Davis-Besse Nuclear Power Station, Unit No. 1

Response to Request for Additional Information Regarding 10 CFR 50.46 30-Day Report  
(TAC No. ME4780)

Response to Request for Additional Information Regarding 10 CFR 50.46 30-Day Report

Figure 1. SBLOCA 9.5-ft Axial Shape with Characteristic BOC and MOC Limiting Axial Shapes

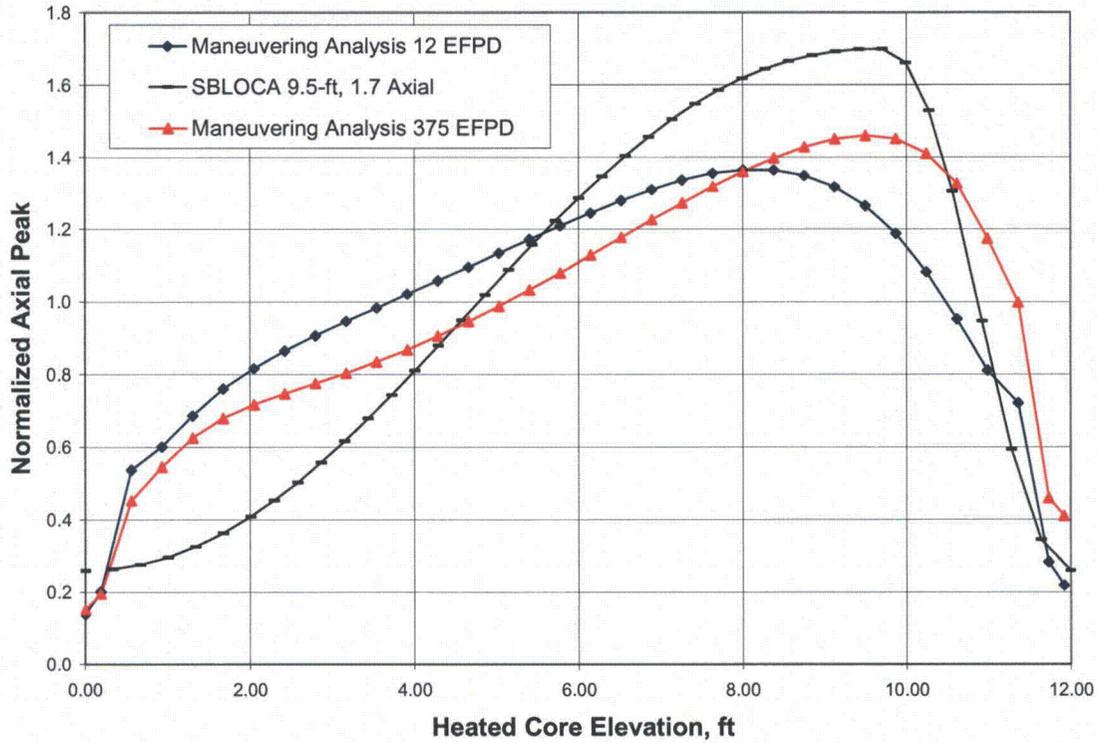
Review of the representative core power distributions showed that at BOC the top-skewed axial power profile was bounded by the 9.5-foot axial power shape used in the current SBLOCA analyses. Figure 1 provides this comparison. Also, shown in this

figure is a middle-of-cycle (MOC) axial power shape at 375 effective full power days (EFPD). The peak locations coincide with the MOC case and the axial shape is also reasonably bounded by the SBLOCA analysis shape. With increasing core burnup, the margins between the maneuvering analysis peaks and the LOCA normalized axial peak increases, but the axial peak elevations are no longer bounded by the shape used in the previous SBLOCA analyses. In Figure 2 the 575 EFPD burnup axial peak is just barely bounded by the 9.5-foot SBLOCA axial shape, but the 715 EFPD elevation of the axial peak is not bounded.

Figure 3. SBLOCA 9.5-ft Axial Shape with Characteristic Limiting Axial Shapes for all Times in Cycle

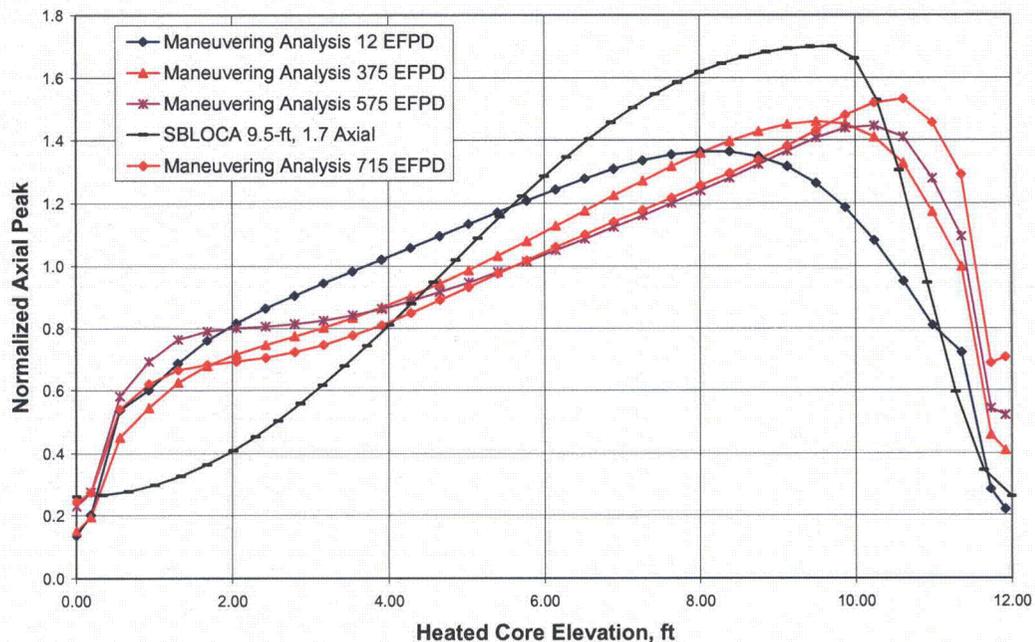
Figure 3 combines all the power shapes and shows the increasing elevation of the axial peaks with increased burnup. To bound the EOC peak elevations, a new SBLOCA normalized axial power shape was created. The 11-foot axial peak selected for use in new SBLOCA analyses is shown in Figure 4 along with the BOC and EOC shapes. The 11-foot shape covers all times in cycle; however, it is very conservative for the BOC case. The EOC peaks were generated by core power distribution cases that typically produce imbalances larger than those allowed by Technical Specifications for plant operation. If the Technical Specification allowable axial power imbalance limits were used, the elevations of the axial peaks would not change, but the magnitude of the axial peak would decrease. Unless cycle-specific SBLOCA analyses were undertaken, the 1.7 normalized axial shape peaked at the 11-foot elevation should be used to bound all current and future cycles. The magnitude of the peak is bounding for EOC peaks and its use in the SBLOCA analyses with maximum allowed LHR limits (total peaks) will not impact the plant LOCA limits specified in the Core Operating Limits Report or add considerable efforts to the cycle-specific maneuvering analyses. The described selection imposes additional conservatism on the SBLOCA calculated PCTs by imposing higher axial peaks to avert LHR limit reductions and minimize the burden on the future cycle-specific core peaking design checks.

Figure 5. Quasi-SS SBLOCA Steam and Clad Temperatures with a 10 ft Mixture Level at 20 Minutes

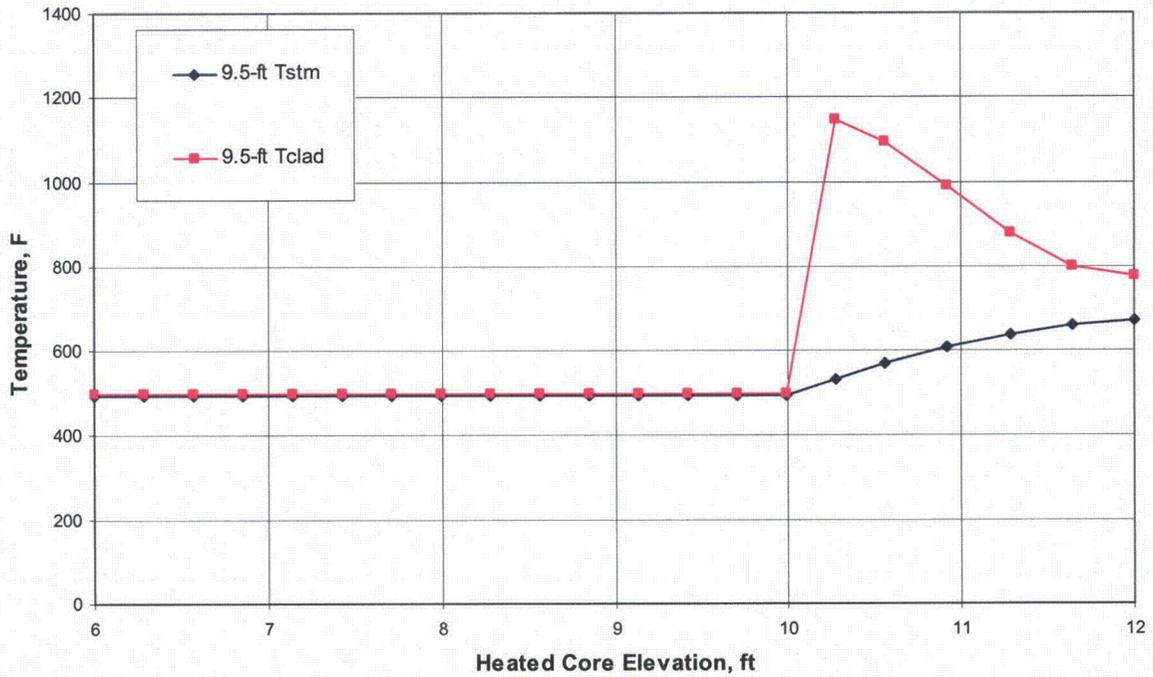
PCT is lower. The core power decreases above the original 9.5-foot axial peak in the core; therefore, the cladding temperature decreases with increasing elevation. Figure 5 shows a representative steam and cladding temperature approximation when the 9.5-foot axial peak is used with a 10-foot mixture level. In this case, the peak power location is below the mixture level and the PCT is predicted at approximately 10.3 feet with a steam temperature that is closer to the saturation value. The PCT occurs at a location in the rod with a power level that is considerably lower than the total peak. Since the power peak is lower, the PCT is lower.

Figure 6. Quasi-SS SBLOCA Steam and Clad Temperatures with a 10 ft Mixture Level at 20 Minutes

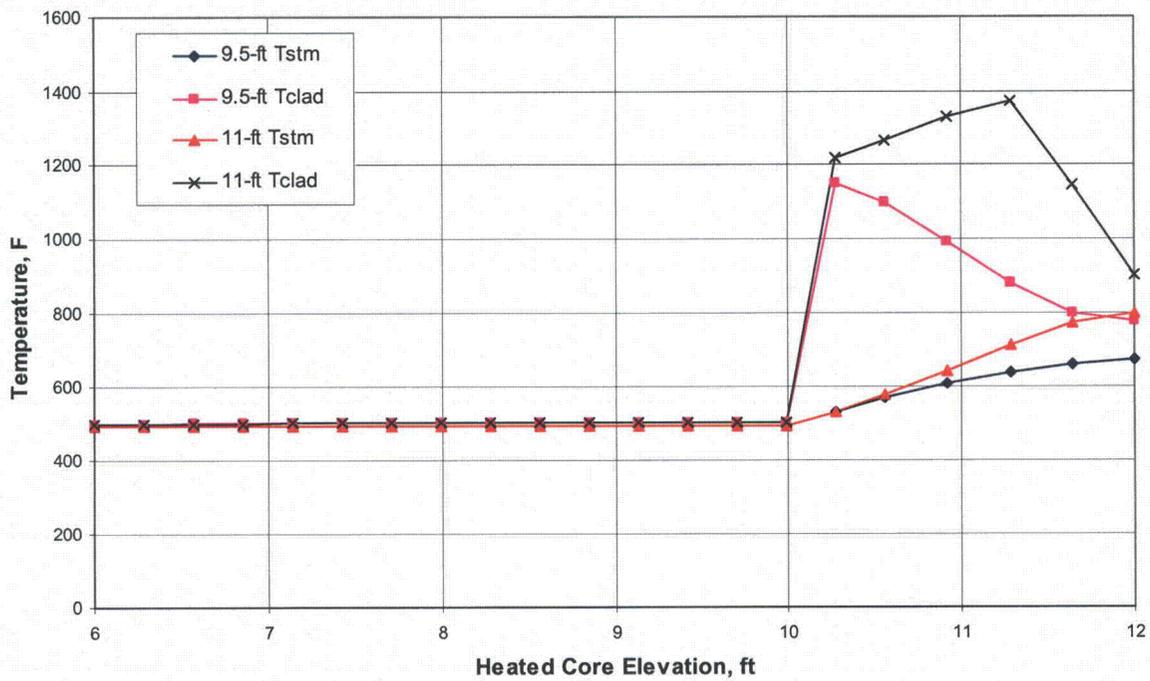
When the 11-foot axial peak is used for a similar case, the PCT occurs near the peak power location. Figure 6 adds the cladding and steam temperatures for the 11-foot axial peak along with the 9.5-foot temperatures from Figure 5. The two key differences are that the steam temperature and power generation are higher. Consequently, the steam temperature plus the temperature difference between the cladding and steam, results in the maximum PCT value at the 11.3-foot core elevation. This resultant PCT is approximately 225°F higher than the 9.5-foot axial PCT based on the quasi-steady-state prediction.

Figure 7. Plant-Specific Mark-B-HTP SBLOCA PCT Comparison versus Break Size

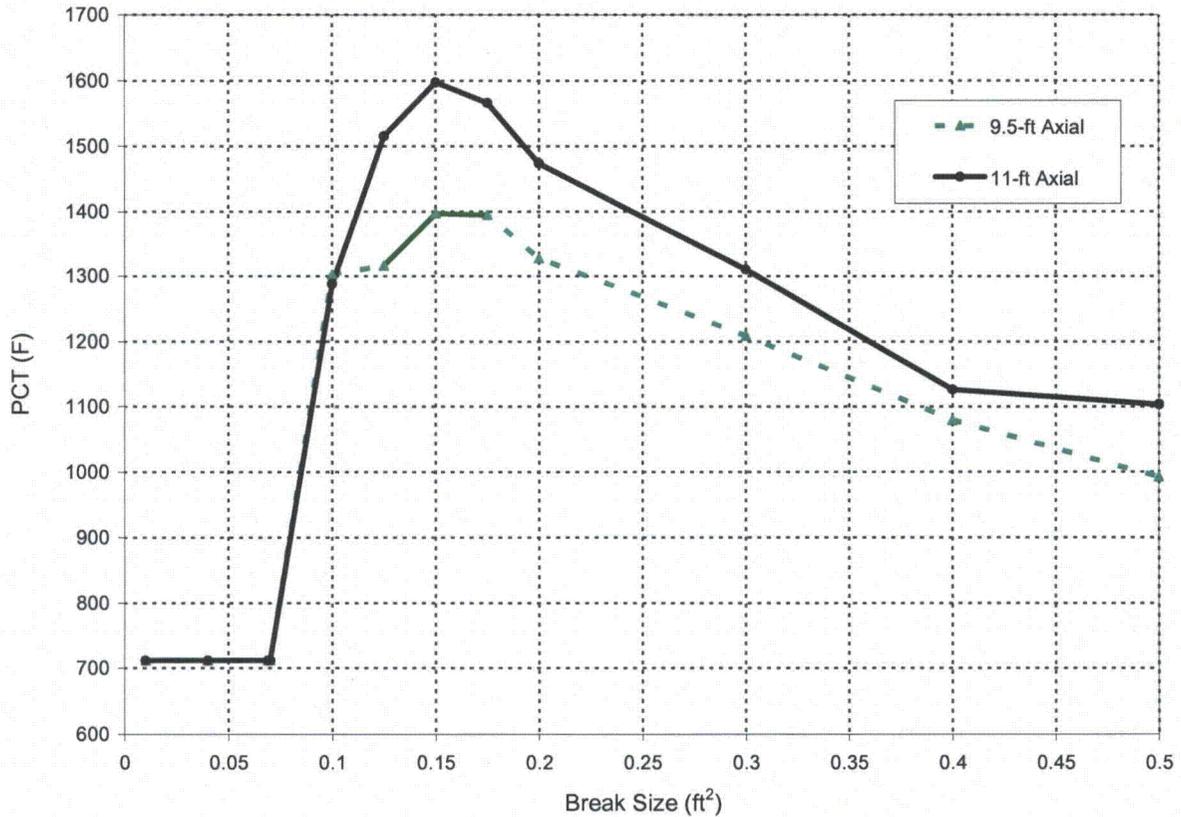
Several cursory SBLOCA RELAP5 cases were performed with the axial power shape changed from 9.5-foot to 11-foot peak elevation. These EM-method based cases also confirmed that the 225°F increase was a bounding value for the PCT cases. Since the time when the issue was identified, one revised SBLOCA spectrum has been completed and documented for one 177-FA lowered-loop plant. These new SBLOCA analyses used the 11-foot axial power shape and other input changes to the actinide decay heat contribution and the steam generator tube plugging fractions. These changes do not significantly change the PCTs, but they would both tend to increase the PCTs slightly. Figure 7 shows the PCT differences for the two cold leg pump discharge (CLPD) spectrums.

The PCT differences observed for the spectrum of CLPD breaks in Figure 7 show that the 225°F value assigned to the PCT is reasonable, yet bounding. The smaller break sizes for this spectrum did not have core uncovering so there was no PCT increase. The intermediate to larger SBLOCAs had PCT increases less than the 225°F value assigned generically to all plants prior to completion of any formal reanalyses. The larger SBLOCA sizes evolve rapidly and do not have time to achieve the quasi-steady-state conditions used to develop the 225°F estimated increase. For these reasons, the PCT differences for larger SBLOCAs will be smaller than the 225°F value assigned to the limiting PCT case. The smaller break sizes have more potential to evolve to the quasi-steady-state conditions that were assumed. These break sizes, however, achieve those conditions at a later time, with a lower decay heat level and generally higher mixture level. When the decay heat is lower, the cladding to steam temperature difference is less and the PCT increase will be less than the 225°F assigned to all breaks with core uncovering at an earlier time period in the CR evaluation. The overall conclusion is that the PCT increase for all plants is expected to be less than the 225°F estimate created to provide a reasonable bounding value for the limiting SBLOCA.

Note: There are several minor input differences other than the axial power shape included in these spectrum results. In the 11-foot SBLOCA spectrum analyses, the steam generator tube plugging is higher by 2 percent, there was a full-core Mark-B-HTP fuel, and higher actinide decay heat contribution. It is estimated that the increase in PCT from the other changes is 20 to 40°F. In addition, the PCTs for the 9.5-foot cases other than at 0.125, 0.15, and 0.175 feet<sup>2</sup> were estimated based on analyses with a different fuel design. The Mark-B-HTP 9.5-foot axial analyzed cases are shown as a solid line and the estimated cases based on the Mark-B11 fuel design is shown as a dashed line.
